Project	<b>IEEE 802.16 Broadband Wireless Access Working Group</b> < <a href="http://ieee802.org/16">http://ieee802.org/16</a> >	
Title	<b>Comment on Unsolicited RNG-RSP in transparent RS System</b>	
Date Submitted	<b>2007-07-18</b>	
Source(s)	Kanchei (Ken) Loa, Yi-Hsueh Tsai, Yung-Ting Lee, Hua-Chiang Yin, Shiann-Tsong Sheu, Youn-Tai Lee,	Voice: +886-2-27399616 Fax: +886-2-23782328 loa@iii.org.tw
	Institute for Information Industry 8F, No. 218, Sec. 2, Dunhua S. Rd., Taipei City 106, Taiwan	
Re:	IEEE 802.16j-07/019: "Call for Technical Comments Regarding IEEE Project 802.16j"	
Abstract	This contribution proposes the modified figures of MS unsolicited RNG-RSP in non-transparent RS system under centralized scheduling scheme based on comment #1141 of 80216j-07_014r4.cmt.	
Purpose	Text proposal for 802.16j Baseline Document.	
Notice	<i>This document does not represent the agreed views of the IEEE 802.16 Working Group or any of its subgroups. It represents only the views of the participants listed in the "Source(s)" field above. It is offered as a basis for discussion. It is not binding on the contributor(s), who reserve(s) the right to add, amend or withdraw material contained herein.

Figure 108f—Unsolicited RNG-RSP ~~in Transparent RS system~~ triggered by upstream traffic at Transparent Access RS

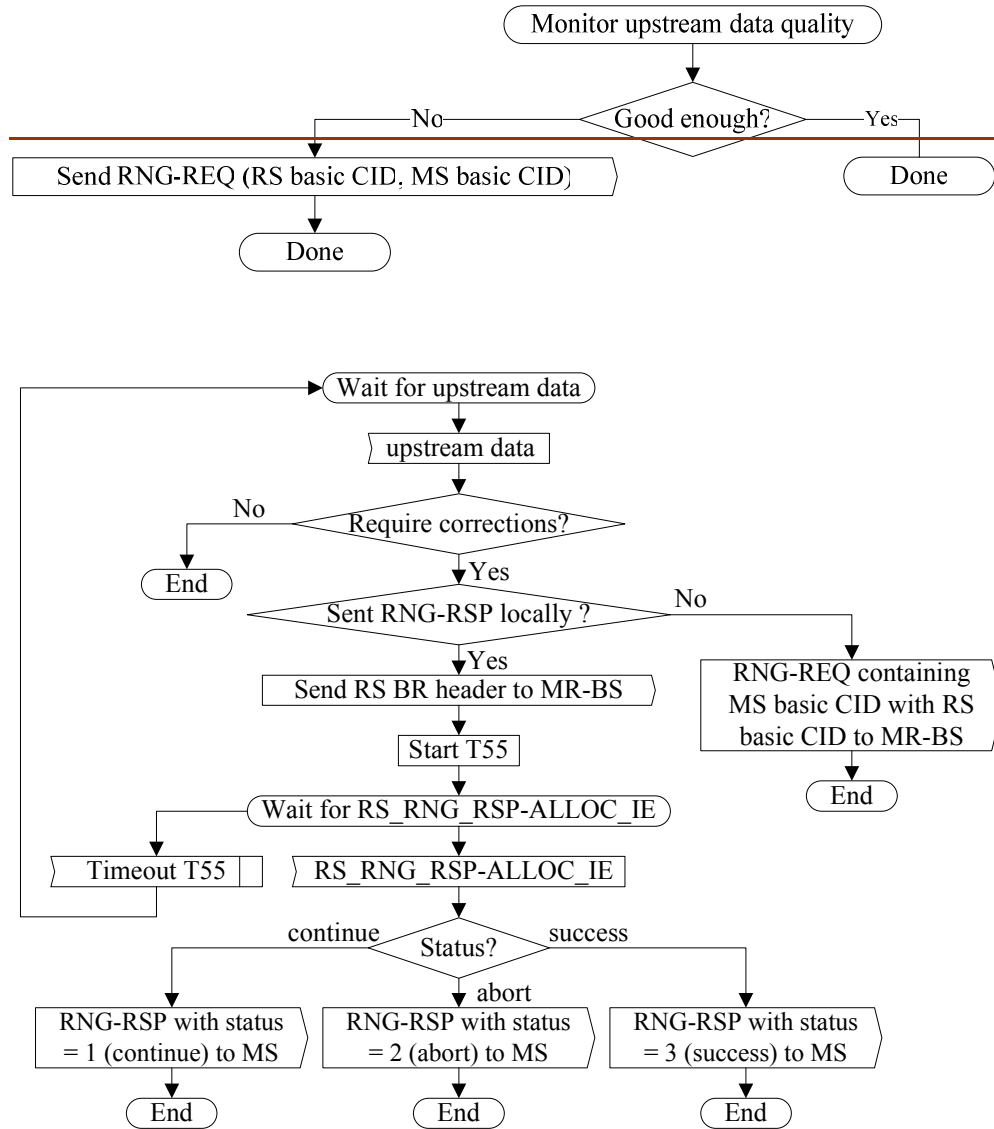
Table 201d—Unsolicited RNG-RSP triggered by upstream traffic in non-transparent ~~RS system mode~~  
 [Replace the following Figure 108f in page 99 as indicated]

Figure 108g ~~Unsolicited RNG-RSP in Transparent RS system~~ Handle RNG-REQ in transparent mode at MR-BS

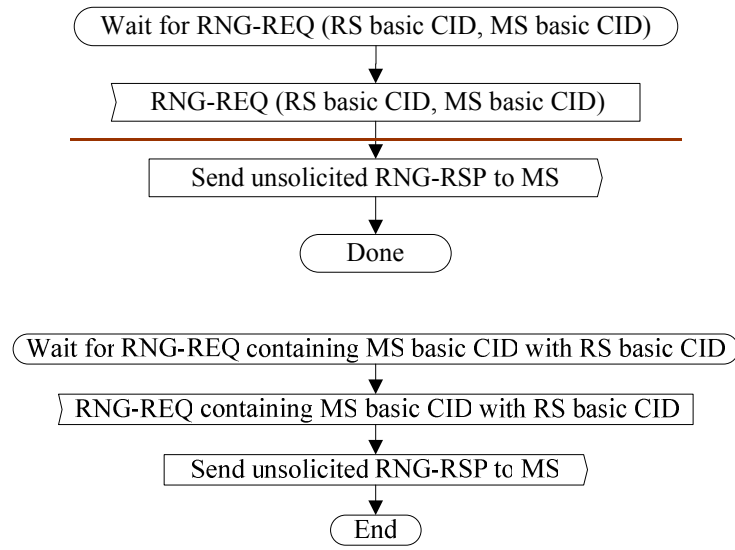
[Replace the following Figure 108g in page 99 as indicated]

Figure 108h ~~Unsolicited RNG-RSP triggered by CDMA BR ranging code in Transparent RS system at~~ Transparent Access RS

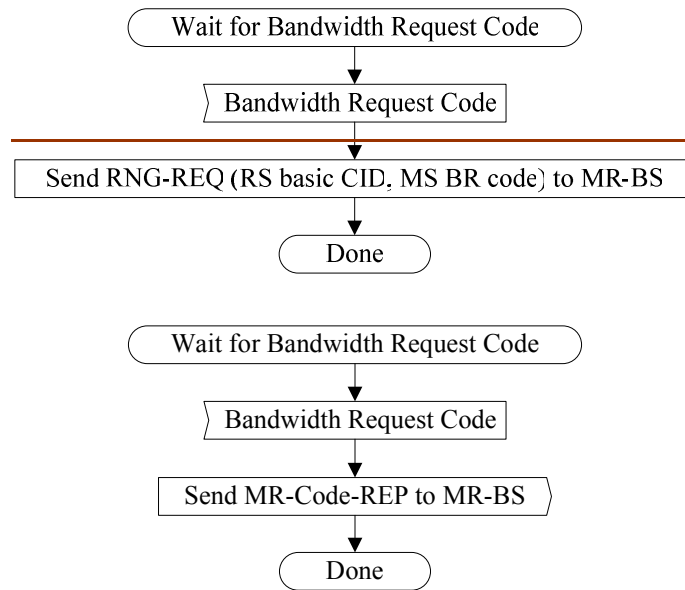
[Replace the following Figure 108h in page 99 as indicated]

Figure 108i Unsolicited RNG-RSP triggered by CDMA BR ranging code in Transparent-RS system mode at MR-BS

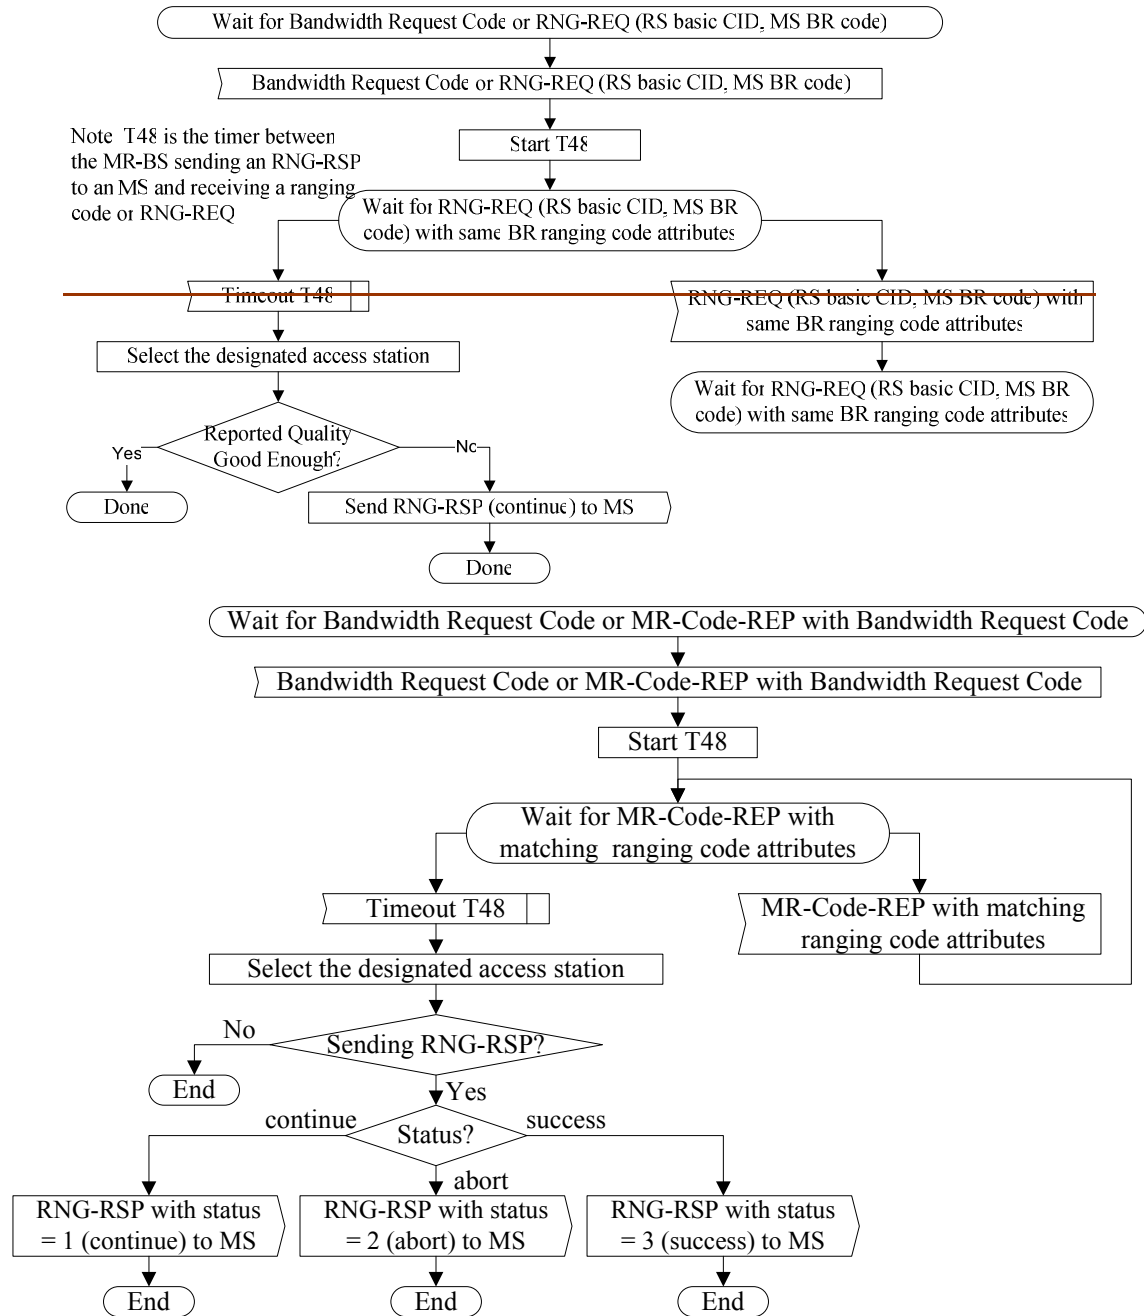
[Replace the following Figure 108i in page 99 as indicated]
